# UNITED STATES PATENT AND TRADEMARK OFFICE

10/563,422

<b>Office Action Summary</b>	<b>Application No.</b> 10/563,422	<b>Applicant(s)</b> JACOBSEN, PER	
	<b>Examiner</b> Dinesh Vesra	<b>Art Unit</b> 3633

## DETAILED ACTION

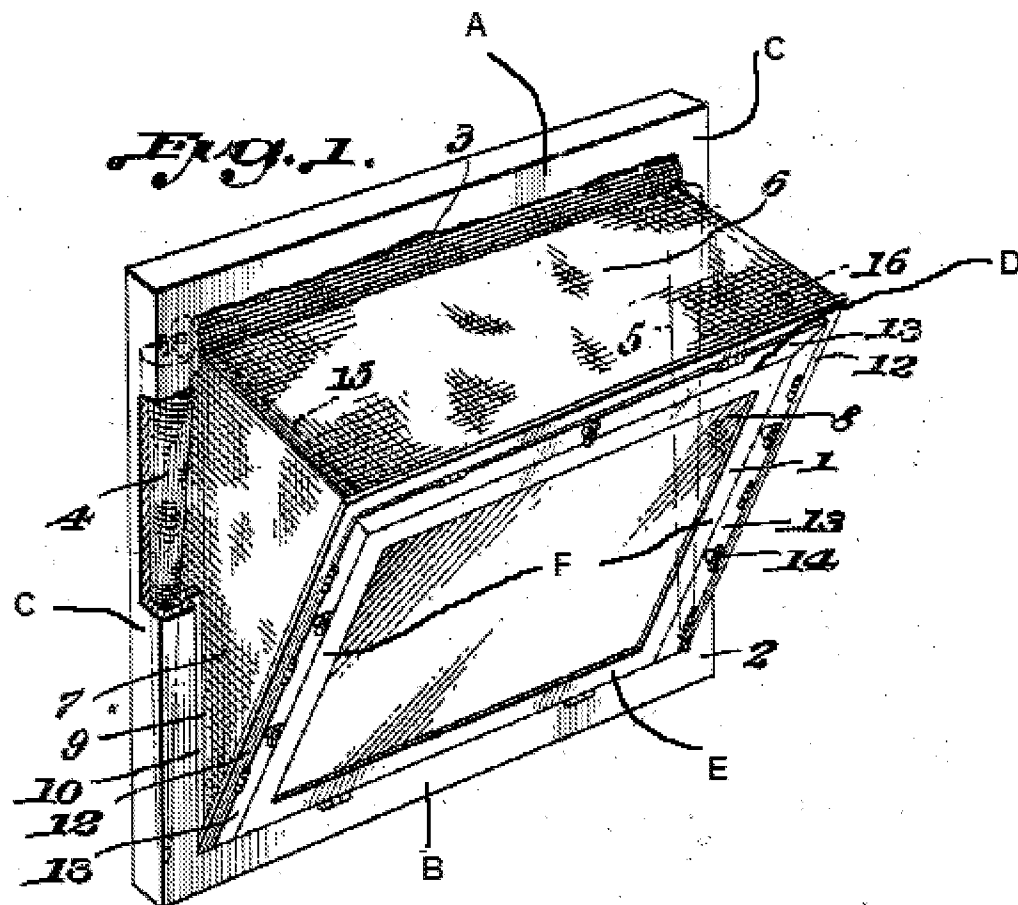
7. **Claims 18, 19 are rejected under 35 U.S.C. 102(b) as being anticipated by Persson (US Patent 2,311,413).** Persson discloses a window (see Fig. 1 below) comprising a frame (2) having a top member (A), a bottom member (B) and two side members (C) defining a frame plane; a sash (1) having a top member (D), a bottom member (E) and two side members (F) defining a sash plane; a screening arrangement (7); the sash being connected to the frame by means of at least one hinge (Column 1, lines 58-60) connection to provide a hinge axis substantially parallel with the frame top member and the sash top member, such that the sash may be moved from a closed position to a ventilating position, in which ventilating position the sash plane forms an angle within a limited angle range with the frame plane to provide at least one ventilating Aperture, said screening arrangement covering said at least one ventilating aperture at least partly in the ventilating position; said screening arrangement comprising at least one screening element (7) which in closed position of the window, is arranged in an inactive position at the interface (12 – Fig. 2) between frame and sash, and in the ventilating position spans the ventilating aperture between the frame bottom member and the sash bottom member, and/or between the frame top member (A) and the sash top member (D), and that the at least one screening element is connected with the sash or frame top or bottom member and is in releasable engagement (13) with the corresponding frame or sash member within said limited angle range, wherein said at least one screening element is provided exclusively at the top and/or bottom member of the sash and the frame (as shown in Fig. 1 below); wherein the at least one screening element of the screening arrangement is adapted to be moved automatically from an

inactive position corresponding to the closed position of the window to an active position corresponding to the ventilating position, and from the active position to the inactive position when the window is brought from its ventilating position to its closed position (Column 1, lines 16 - 20); wherein the screening arrangement further comprises interface screening means arranged at the interface between the screening element and the sash side members (F).
